Final Drainage Report

Lot 1 The Rock Commerce Center

Subdivision Filing No. 1

July 28, 2023
Project No. 23009.001

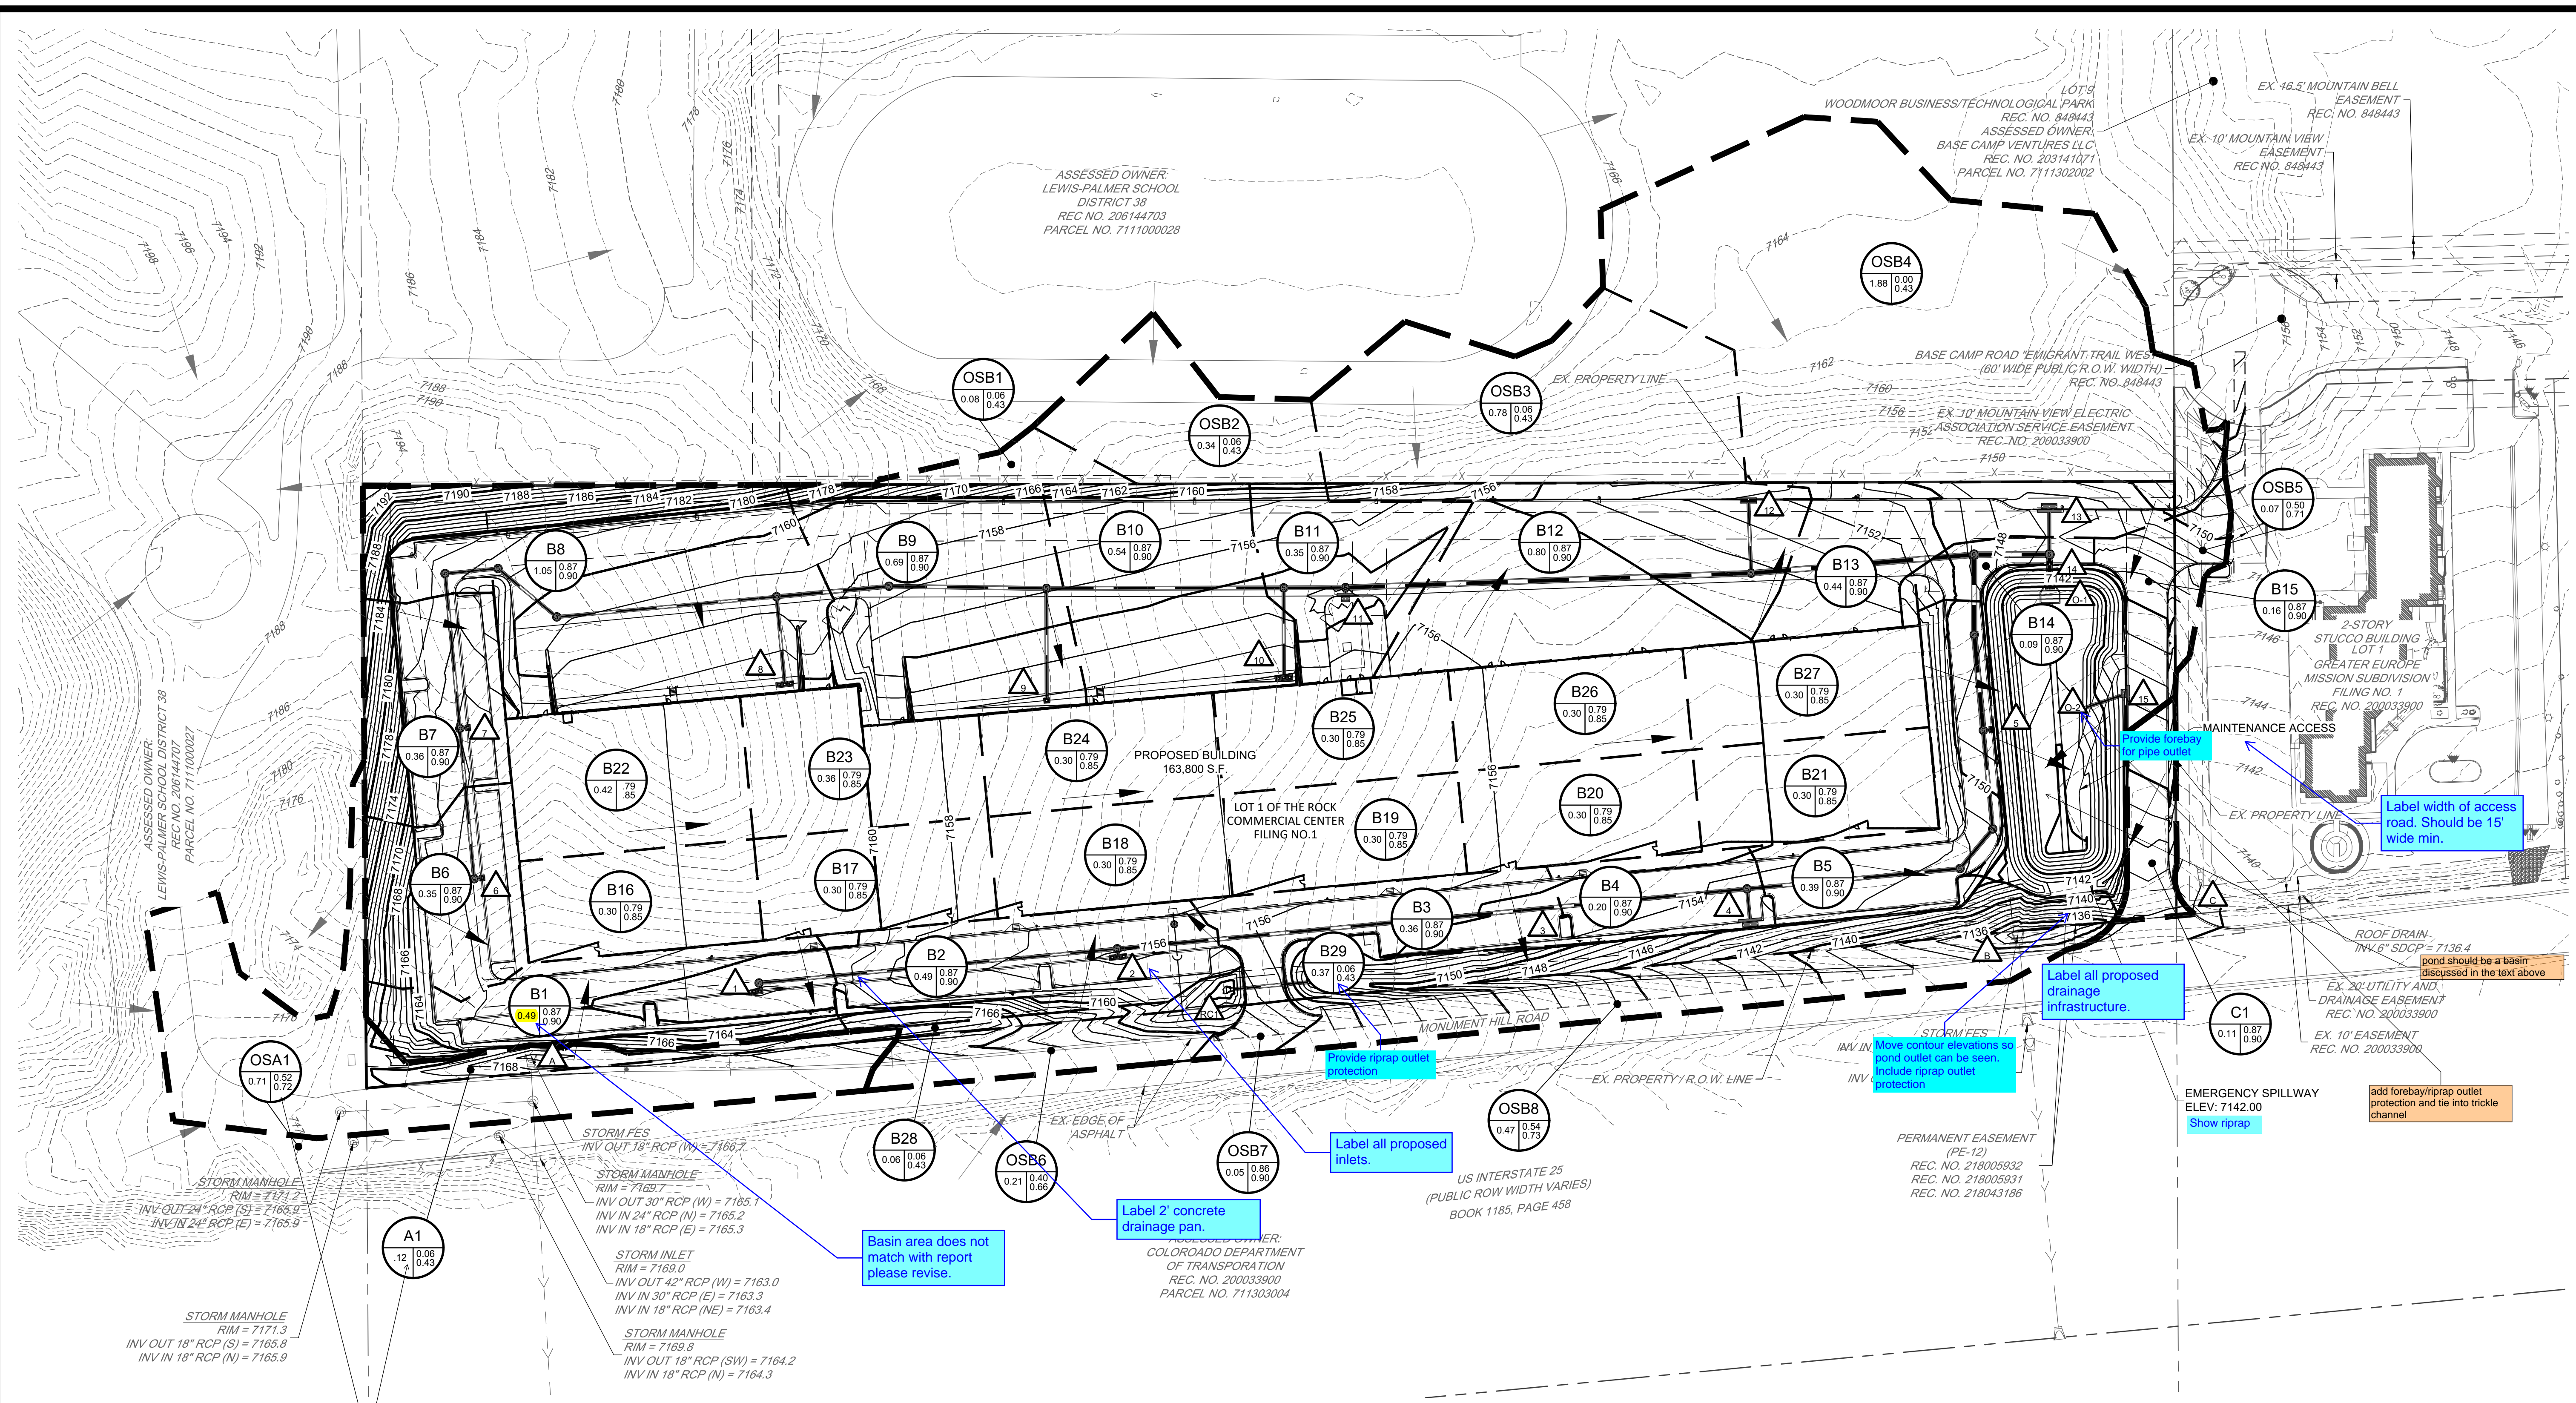
Show and label drainage chase on plans

Show overtopping route of flow on proposed drainage map

Water surface elevations do not match with information from MHFD Detention spreadsheet
